GROUP	MODEL
BOD	2023MY Carnival (KA4)
NUMBER	DATE
311	October 2022

## TECHNICAL SERVICE BULLETIN

### SERVICE ACTION: FRONT DOOR WEATHERSTRIP INSPECTION AND REPLACEMENT (SA510)

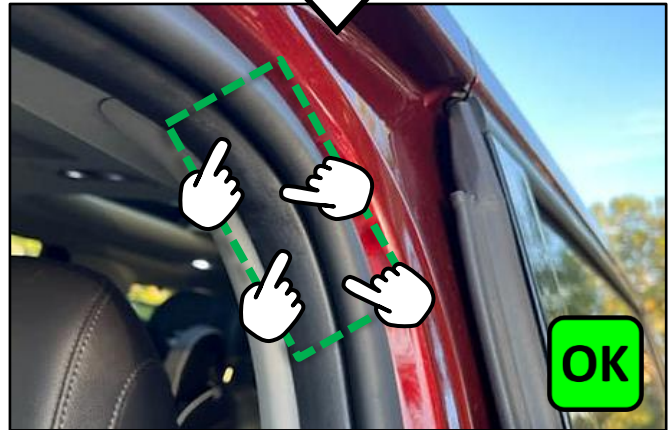
Press the weatherstrip in the upper "B" pillar corner areas shown with your finger and confirm the following:

- If the weatherstrip **does not deform (OK)**, (retracts normally after pressing), then no further action is needed.

- If the weatherstrip **does deform (NG)**, (does not retract when pressed), then proceed to the 'Replacement Procedure' on page 3 to replace the weatherstrip on the affected door(s) (LH, RH, or Both).

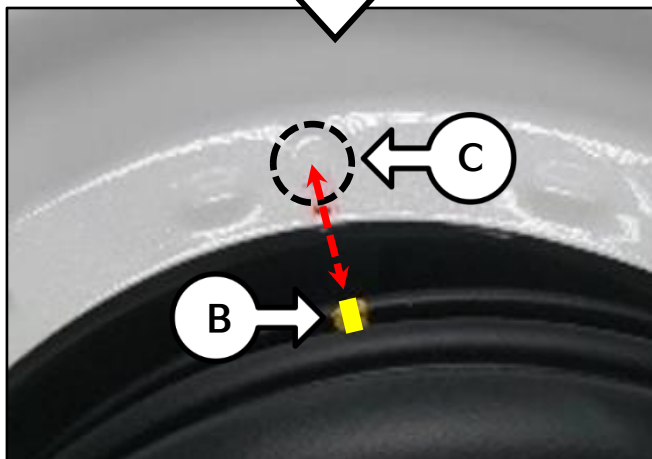
1. Remove the affected front door weatherstrip (A) (Left, Right or Both) on the body side.

2. Install the new weatherstrip (A) securely into the channel around the door frame.

Locate the color marking on the new weatherstrip to differentiate between Left and Right side:

- Driver's (LH): White mark
- Passenger (RH): Yellow mark

Match the color mark (B) on the weatherstrip with the spot-welding mark (C) on the top rear corner of the door opening.
